2 ARCHITECTURAL ADDENDUM

3 MECHANICAL ADDENDUM

**The following changes/clarifications in the tender documents are effective immediately.
This addendum will form part of the contract documents.**

PACIFIC AGRI-FOOD
RESEARCH CENTRE
MECH & ELEC RETROFIT

OVERALL SITE PLAN

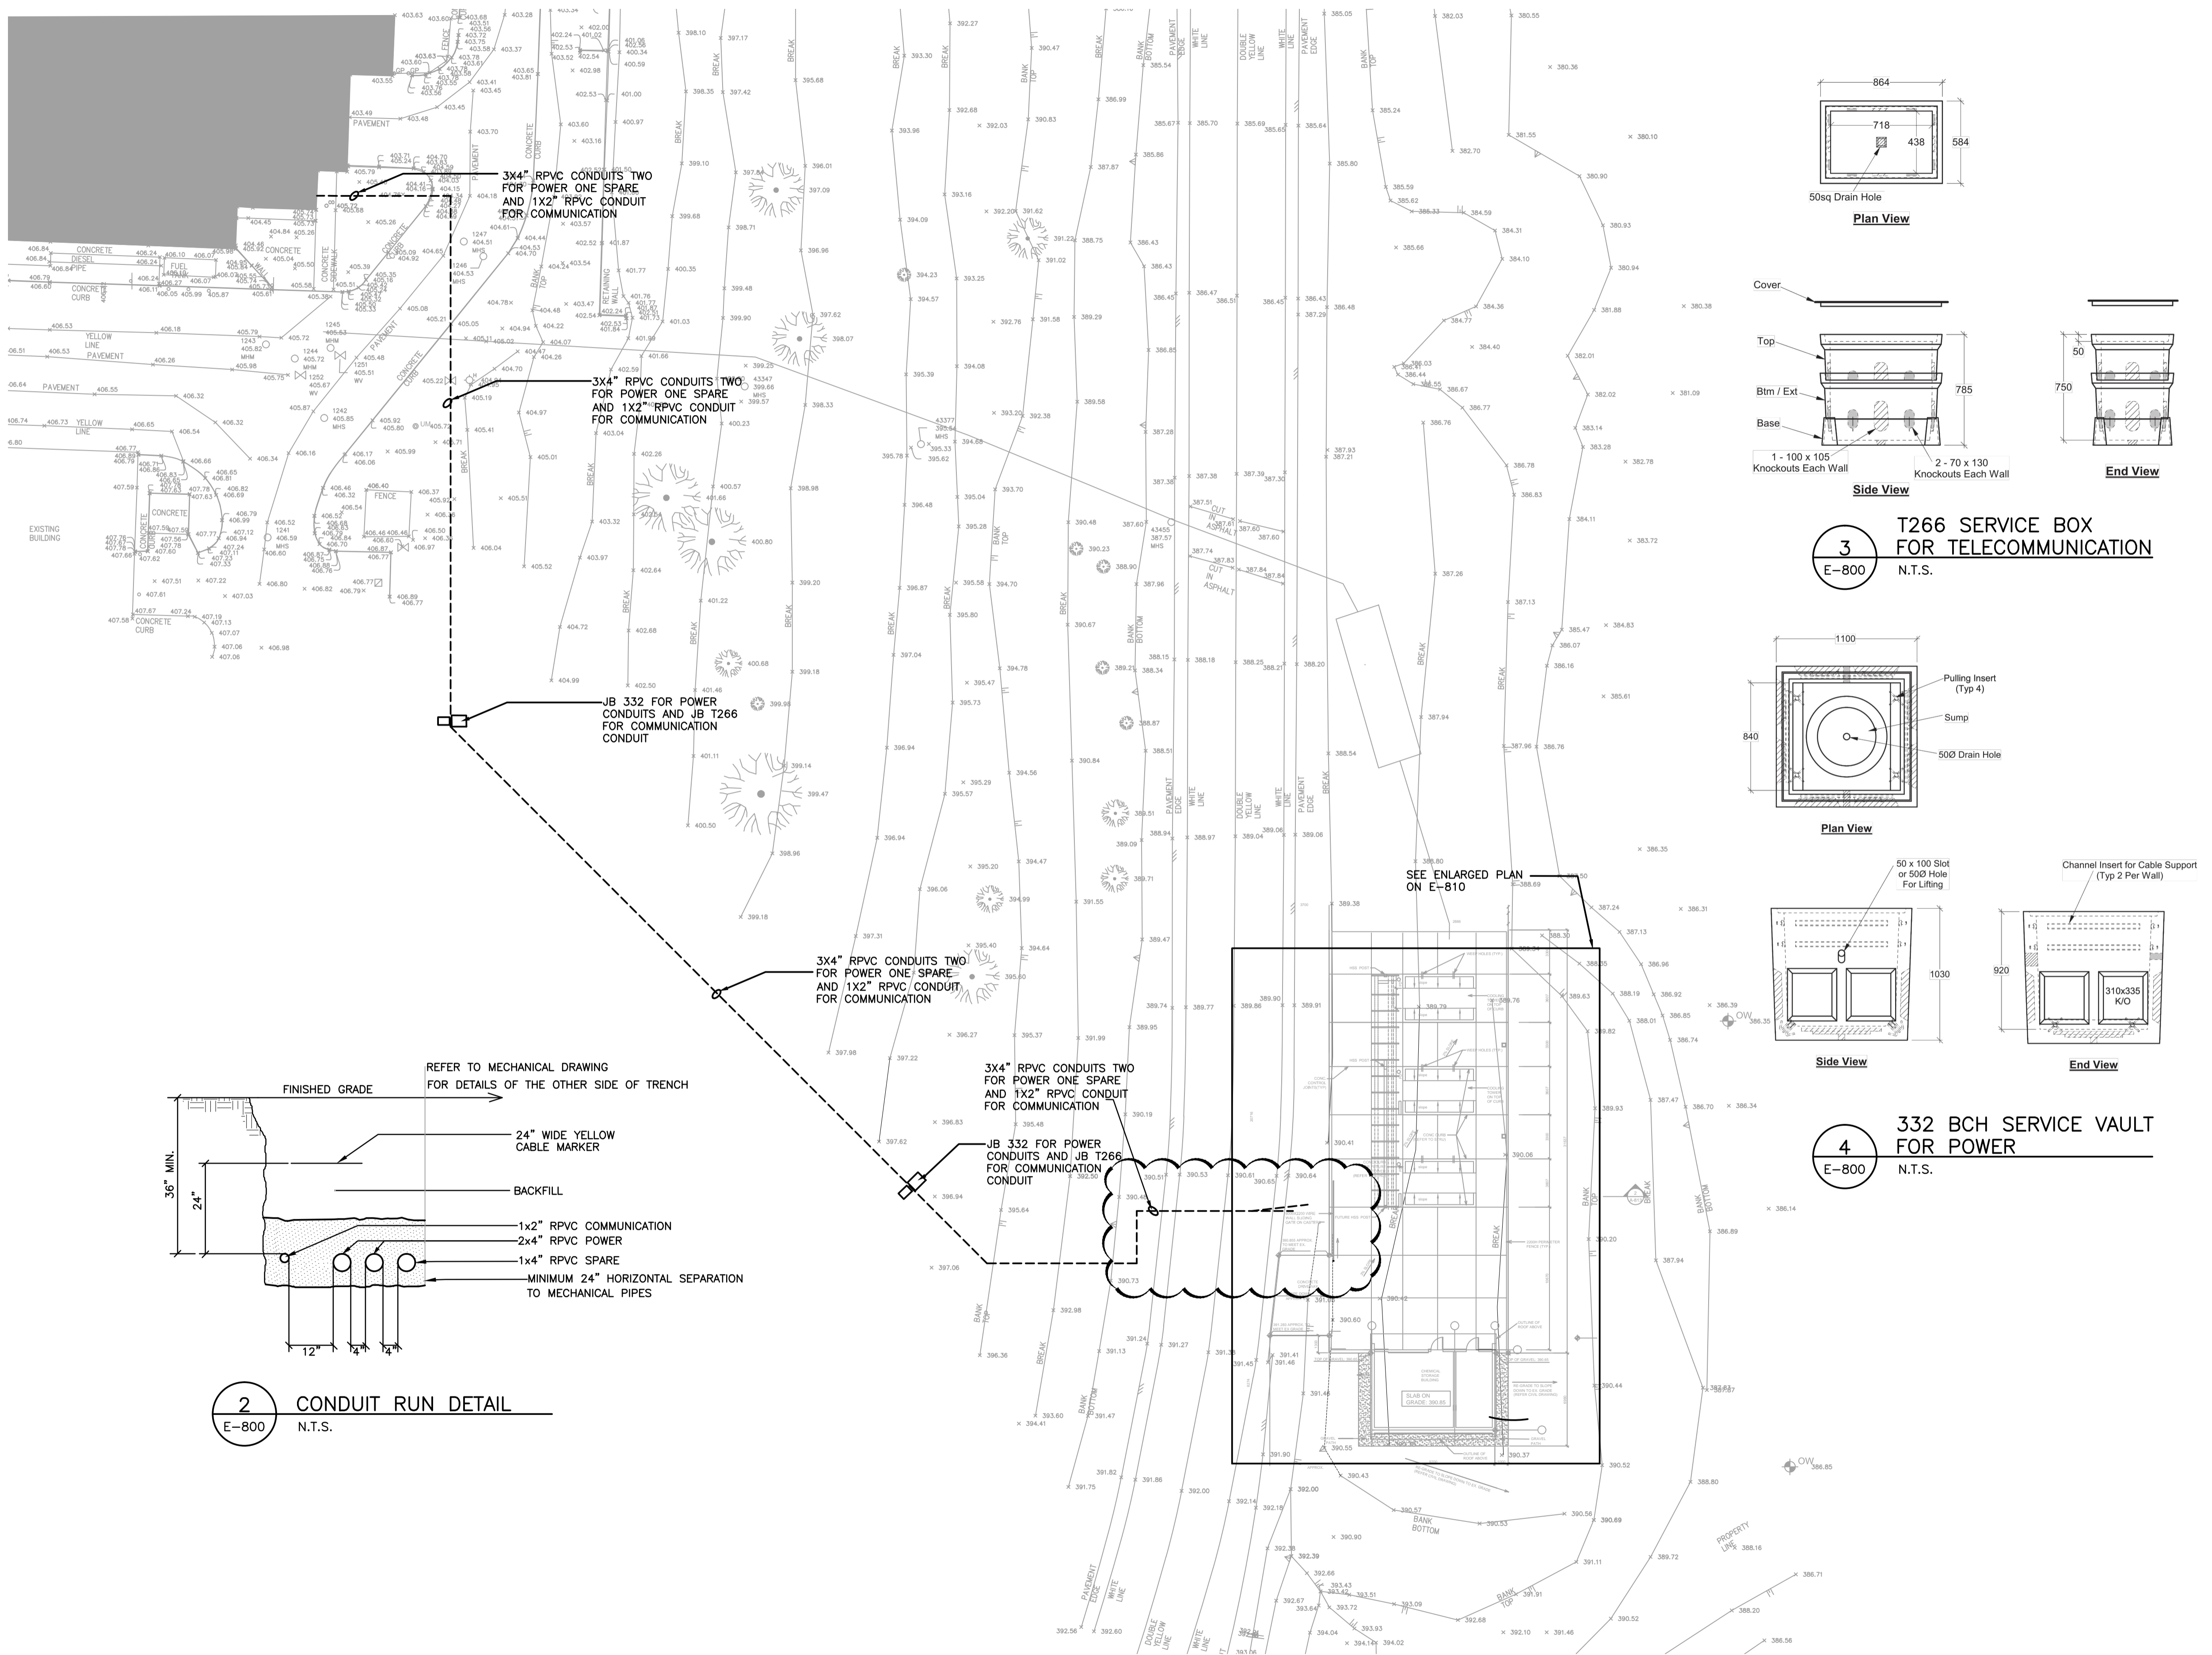
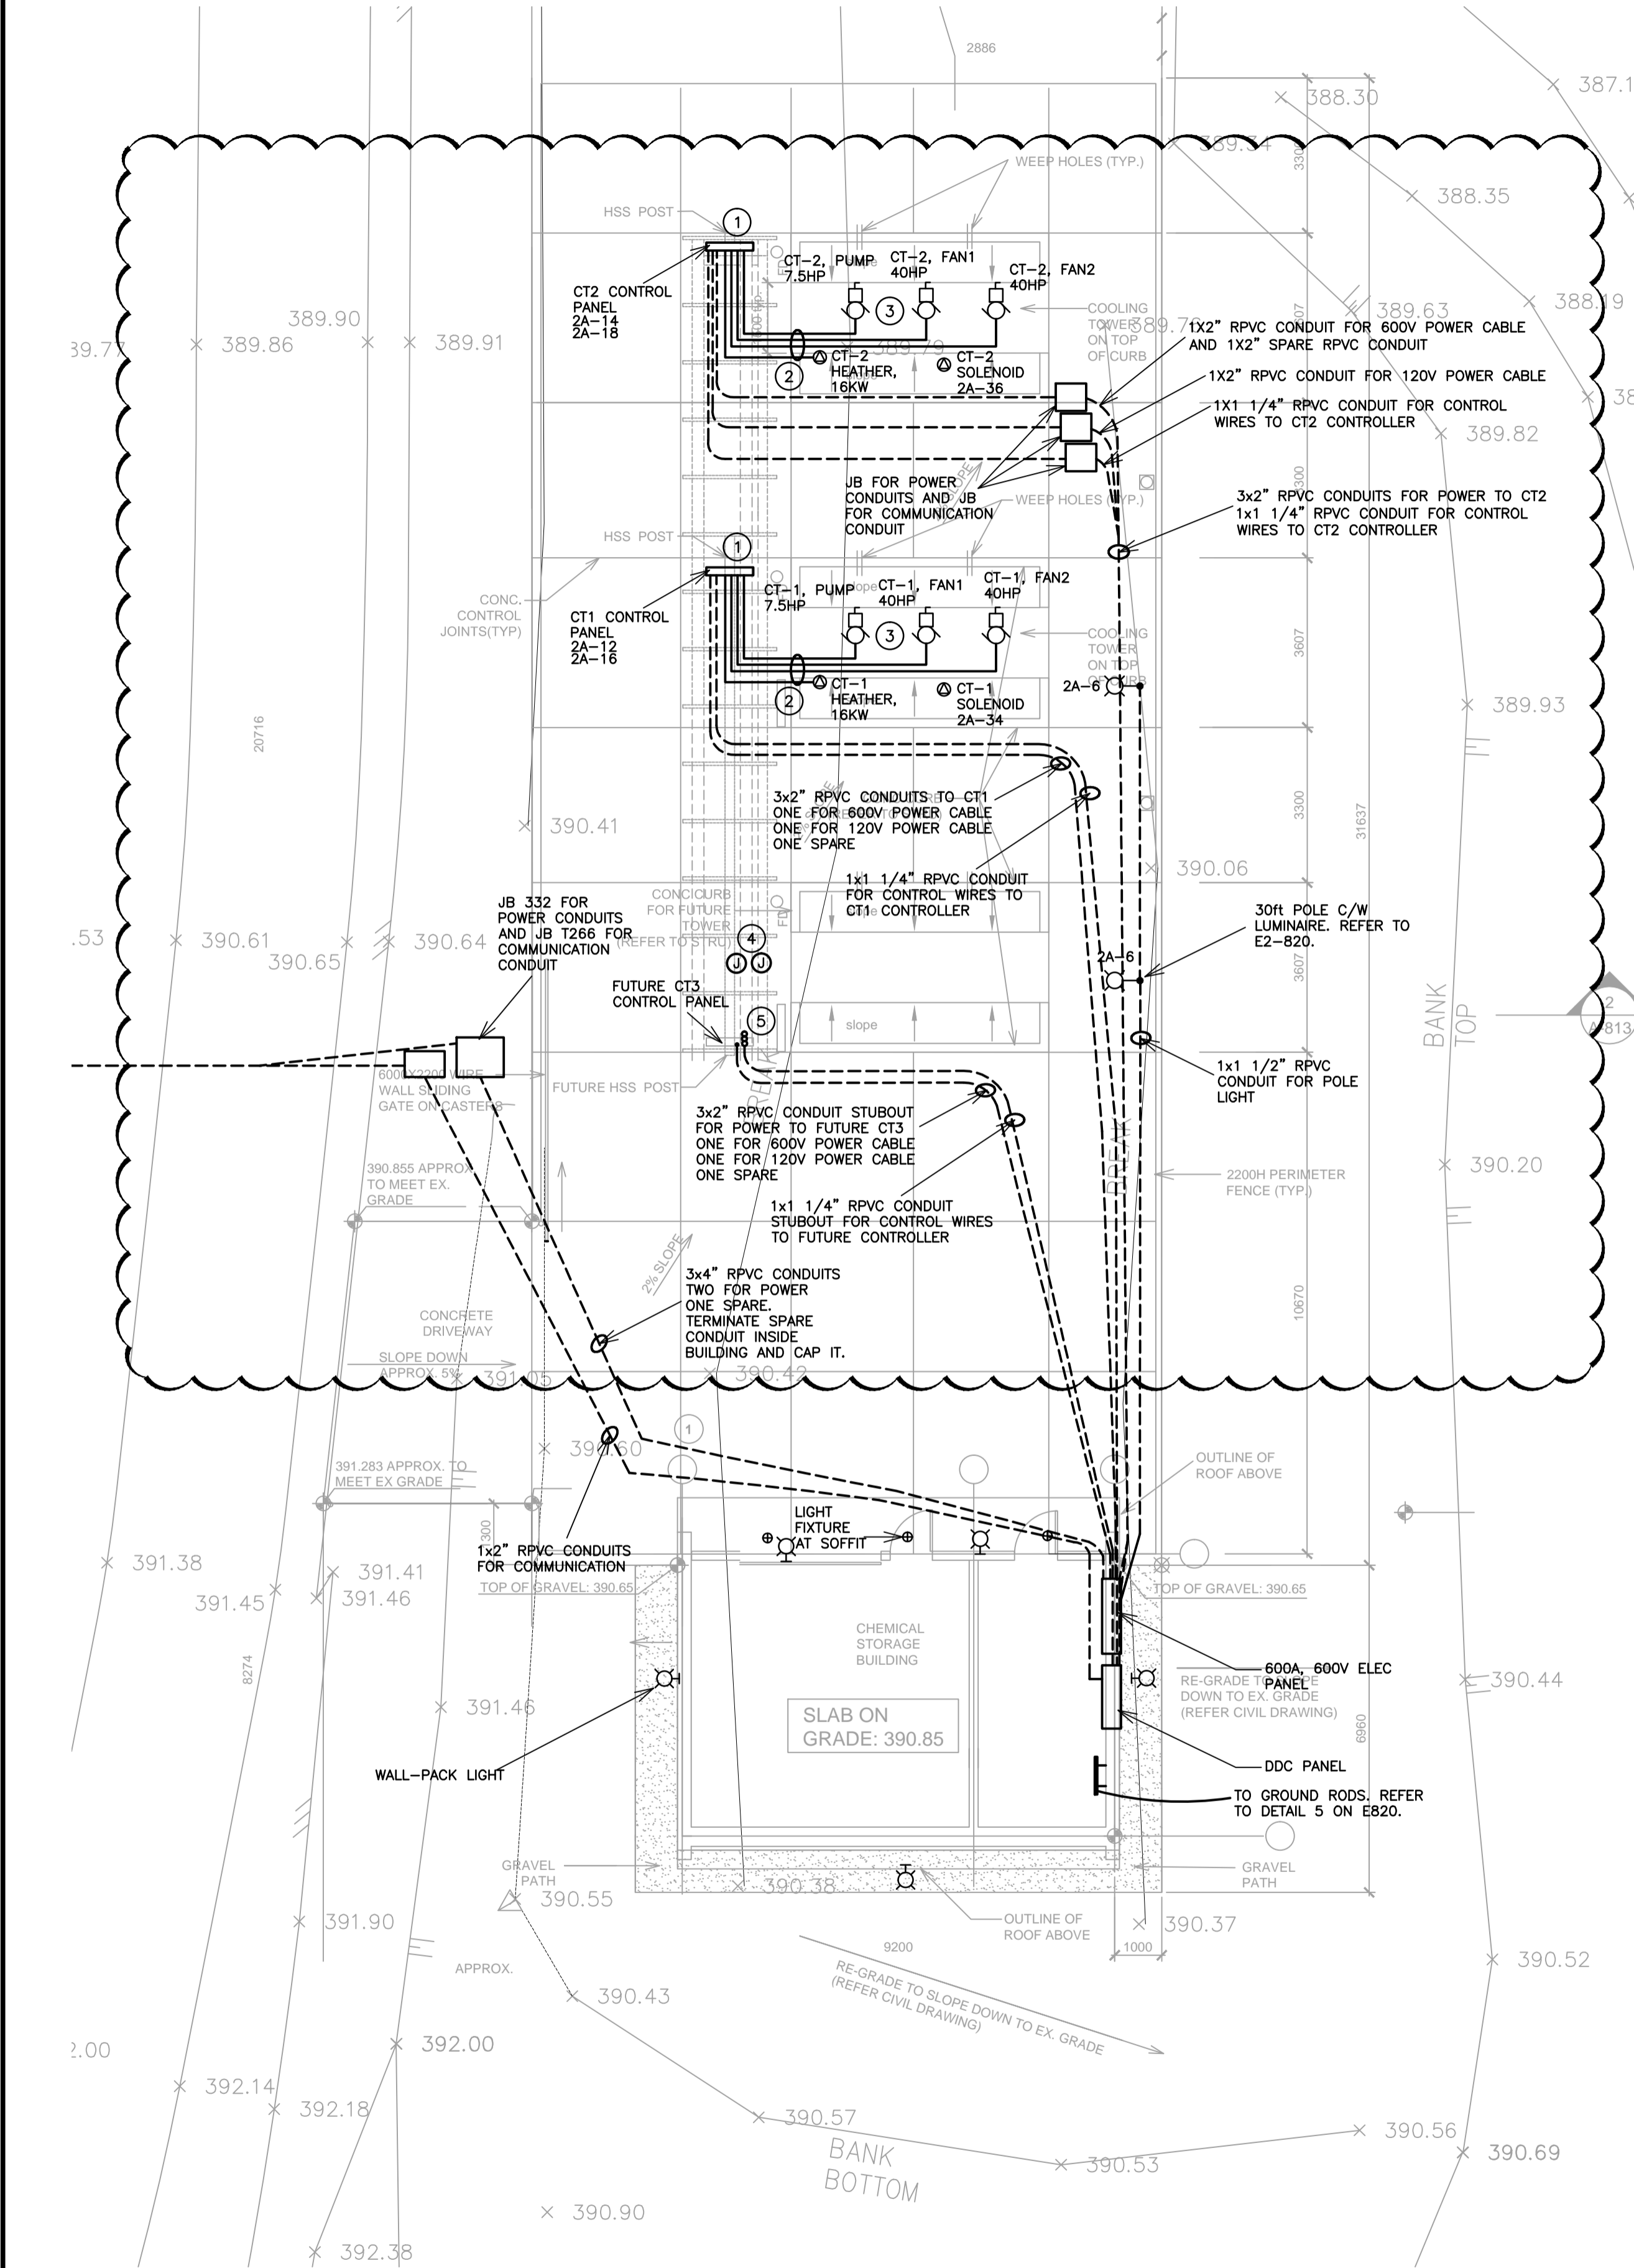
- .1 Refer to drawings E-150, E-800, E-810, E-820 attached
- .2 Drawing E-150
 - .1 Add drawing scale and scale bar.
- .3 Drawing E-800
 - .1 Move conduits for power and communication to follow the same trench path as mechanical pipes.

- .2 Add drawing scale and scale bar.
- .4 Drawing E-810
 - .1 Move JB 332 and JB T266 to outside the fence in the landscape area and to match new conduit trench path.

- .12 Q12: Drawing E-800, BCH Service Vaults. Please confirm that the supply and .12 installation of these precast concrete vaults are in the electrical scope and not the civil scope.

A12: Electrical is to provide & install conduits and concrete vaults.
